This is to certify that W H Nichols Company/Sheffield Corporation
has permission to Build 27x26 dumpster shed
AT 2400 Congress St 236 A003001

To: Dana Sturdivant
From: Mike Nugent/Manager of Inspection Services
Date: 07/02/2004
Re: 2400 Congress St. (236 A003)

DATE	6-22-04	JOB NO.	83864
ATTENTION	Mr. Michael Nugent		
RE	Nichols of Portland		
Structural Plan for Building Permit Nichols of Portland 2400 Congress Street Portland, Maine

RE: Nichols Portland; 2400 Congress Street
Proposed Dumpster Shed Roof

PLAN VIEW

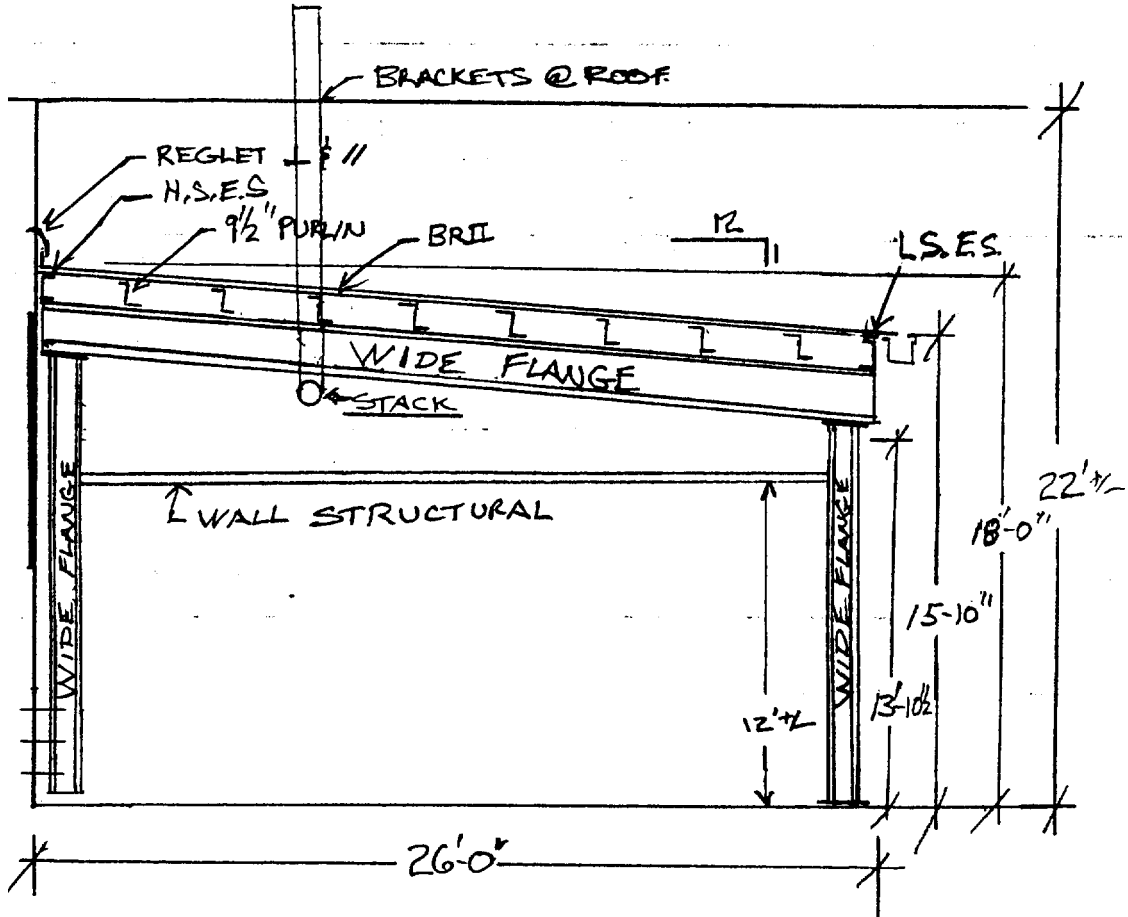
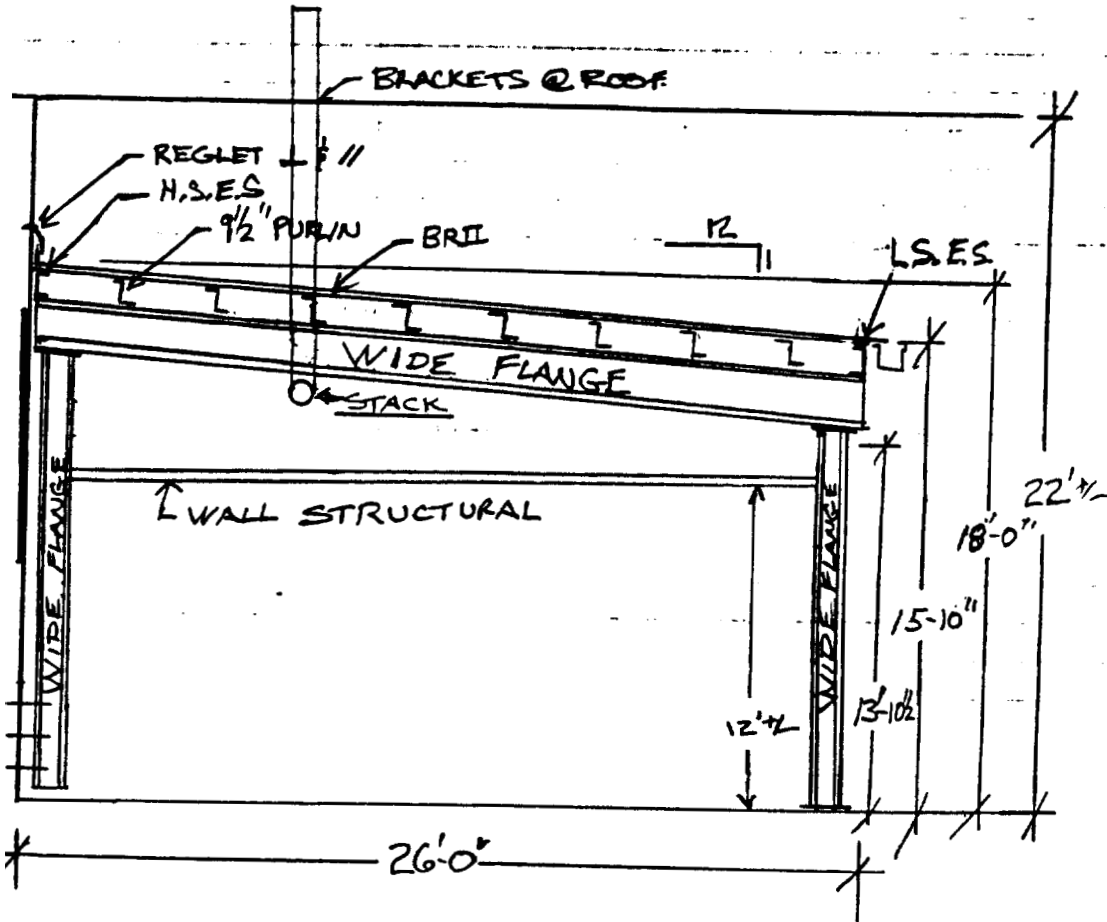
Attached are the proposed construction plan view, a cross section of the proposed shed roof, and a copy of a photograph depicting the existing site condition (seven copies of each). As you see, this shed roof is being constructed **over** an existing impervious surface – asphalt and an exterior concrete slab. **This** structure will not change the storm water flow in any way. The existing slab and asphalt slopes to an existing catch basin, as depicted on the attached sketch and copy of the photo.
